Access Compliance Report

Public Rights-of-Way

(Curb Ramps)

Intersection ID: 25287	Main Street: CEDAR_POINT_LN	Cross Street: JOHNSTON_RD	Location: SE
ADA ID: EDE73C1E6022	Ramp Type: PerpDiag	Initial Pass/Fail: Fail	Overall Compliance: No
Severity Score: 12.5			
Codes/Mitigation Info/Possible Solution		Field Measurements/Component Compliance

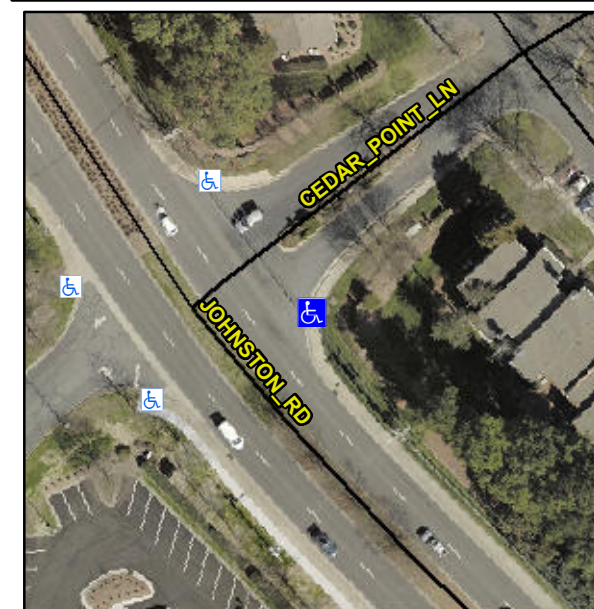
Not Found, R304.2.2

Compliance	Description	Data	Compliance	Description	Data
N/A	Ramp Length (in)	60.0	No	Ramp Slope (%)	8.4
Yes	Ramp Width (in)	48.0	Yes	Ramp XSlope (%)	1.7
N/A	Flare Type LT	N/A	N/A	Flare Type RT	N/A
N/A	Flare Slope LT (%)	N/A	N/A	Flare Slope RT (%)	N/A
N/A	Flare Traversable LT?	N/A	N/A	Flare Traversable RT?	N/A
N/A	Landing Length (in)	N/A	N/A	DWS Provided?	N/A
N/A	Landing Width (in)	N/A	N/A	DWS Contrast?	N/A
N/A	Landing Slope (%)	N/A	N/A	DWS Length (in)	N/A
N/A	Landing X Slope (%)	N/A	N/A	DWS Full Width?	N/A
N/A	Landing Curb? (Y/N)	N/A	N/A	DWS Offset (in)	N/A
N/A	Shared Landing?	N/A			
N/A	Gutter Ponding?	N/A	N/A	Gutter Slope (%)	N/A
N/A	Gutter Lip Ht (in)	N/A	N/A	Gutter X Slope (%)	N/A
N/A	Painted X Walk1?	No	N/A	Painted X Walk2?	No
	X Walk 1 Direction	To NW		X Walk 2 Direction	To SW
N/A	X Walk 1 Width (in)	N/A	N/A	X Walk 2 Width (in)	N/A
	X Walk 1 Slope (%)	3.8		X Walk 2 Slope (%)	7.7
	X Walk 1 X Slope (%)	6.3		X Walk 2 X Slope (%)	0.2

Remove & Replace Curb Ramp With Two New Directional Ramps or Equivalent.
